ITEM: 509 LaFarge Avenue Landmark, Alteration Certificate, & Grant Request

REQUEST: A request to Landmark 509 LaFarge Avenue and a request for an Alteration Certificate, Preservation and Restoration Grant, and New Construction Grant for the property.

LANDMARK ALTERATION
CERTIFICATE APPLICATION

Proposed alterations to the existing house.

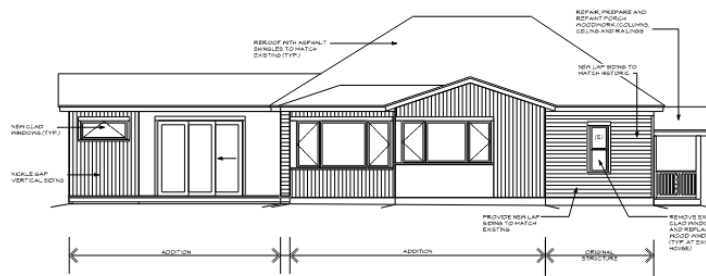
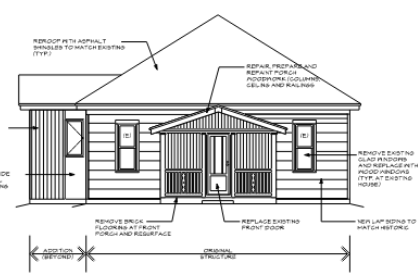
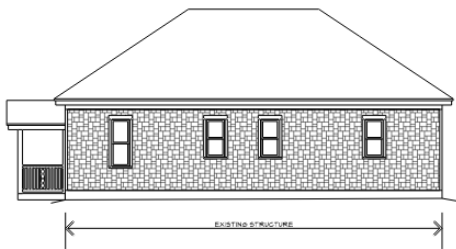
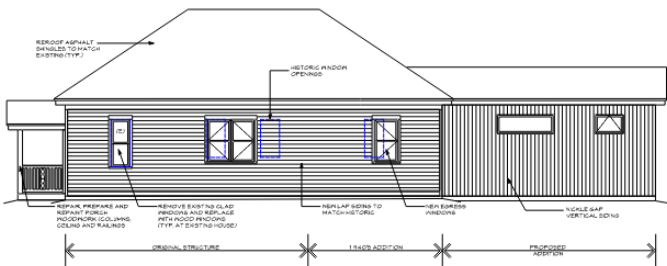
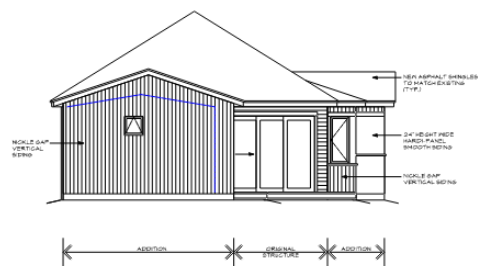
1. <i>The effect upon the general historical and architectural character of the structure and property.</i>	Yes	Requests 1 & 2 The side and rear additions have minimal impact on the architectural character of the structures and property given their subordination to and differentiation from the historic structure.
	Yes	Request 3 The current siding is not original to the historic house, and the porch repairs are intended to preserve character.
	Yes	Request 4 The application proposes to replace existing clad windows with wooden

Criteria and Standards	Met?	Evaluation
		windows on the historic house. Three windows are proposed to be moved, but the number and location on the same wall will remain.

5. <i>The effects of the proposed work in creating, changing, destroying, or otherwise impacting the exterior architectural features of the structure upon which such work is done.</i>	Yes Yes	Requests 1 & 2 The additions would remove minimal amounts of existing materials by removing only portions of the rear exterior walls necessary to connect the additions to the existing structures. Request 3 Residing the house is not expected to impact architectural features of the structure, and the existing siding is not historic.

Criteria and Standards	Met?	Evaluation
	Yes	Request 4 Moving the openings of three existing windows will provide minimal impact on the architectural features, with just the exterior walls directly adjacent to the windows expected to be impacted.
<i>6. The condition of existing improvements and whether they are a hazard to public health and safety.</i>	N/A	The existing improvements do not appear to be a hazard.
<i>7. The effects of the proposed work upon the protection, enhancement, perpetuation and use of the property.</i>	Yes	The proposal will not impact the use of the property.
<i>8. a. A property shall be used for its historic purpose or be placed in a new use that requires minimal change to the defining characteristics of the building and its site and environment.</i>	Yes	The proposal does not affect the continued and historic residential use of the structure.
<i>8. b. The historic character of a property shall be retained and preserved. The removal of historic materials or alteration of features and spaces that characterize a property shall be avoided.</i>	Yes	No characterizing elements would be removed by the proposal.
